**City of Portland, Maine – Building or Use Permit Application** 389 Congress Street, 04101, Tel: (207) 874-8703, FAX: 874-8716

Location of Construction: 294 Summit St		Owner: Ciroux, Kay, Petrie, David		Phone: 797-6184		Permit No: <b>980516</b>	
Owner Address: SAA Field, ME 04103		Lessee/Buyer's Name:		Phone:		BusinessName:	
Contractor Name: Don Neill & Sons		Address: Raymond, ME 655-5077		Phone:		<div style="border: 2px solid black; padding: 5px; text-align: center;"> <b>PERMIT ISSUED</b>                  Permit Issued:  <b>MAY 20 1998</b>  <b>CITY OF PORTLAND</b> </div>	
Past Use: 1-100		Proposed Use: Deck		COST OF WORK: \$ 3,500.00 FIRE DEPT. <input type="checkbox"/> Approved <input type="checkbox"/> Denied Signature:		PERMIT FEE: \$ 40.00 INSPECTION: <b>(u)</b> Use Group <b>43</b> Type: <b>53</b> Signature: <i>[Signature]</i>	
Proposed Project Description: Deck		PEDESTRIAN ACTIVITIES DISTRICT (P.A.D.) Action: Approved <input type="checkbox"/> Approved with Conditions: <input type="checkbox"/> Denied <input type="checkbox"/> Signature: _____ Date: _____		Zone: CBL: 382-B-009 Zoning Approval: _____ <b>Special Zone or Reviews:</b> <input type="checkbox"/> Shoreland <input type="

294 SUMMIT ST.  
PORTLAND, ME.

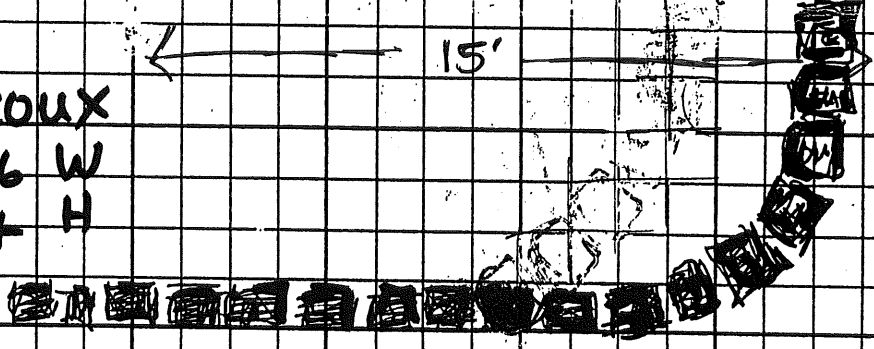
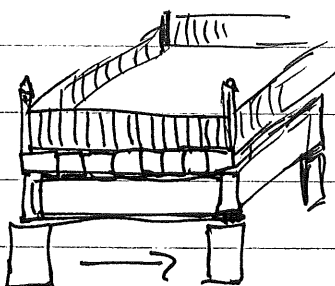
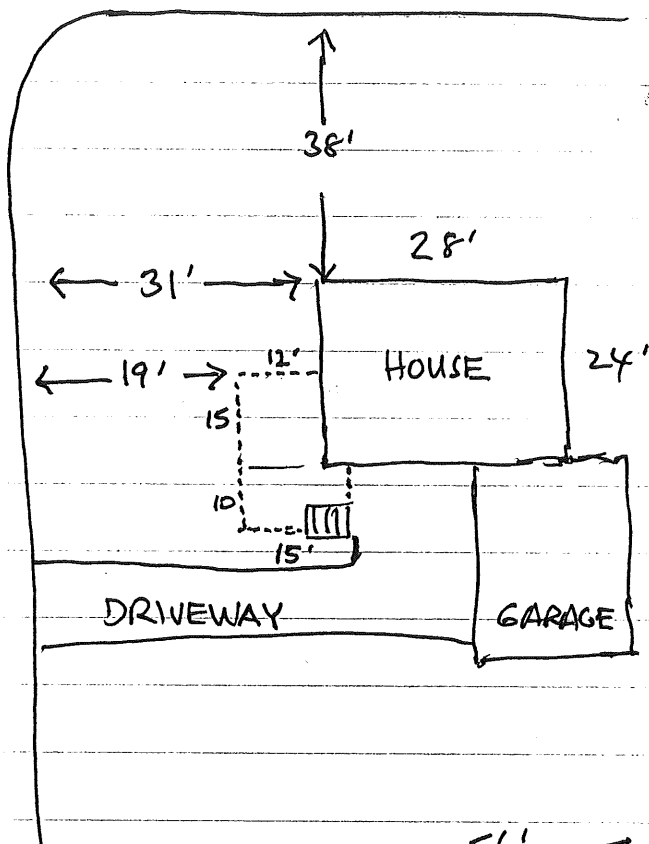
6/2/98 - Called for tubedrops - Side yard (Clayton St Side) appear to close but no defined lines out - Contractor will string out lines & call back @

6/4/98 - Owner identified stone wall on Clayton St as side lot line - Measurement deck to outer edge of wall is 17'4" - ok per Marge S. P. (Photos attached)
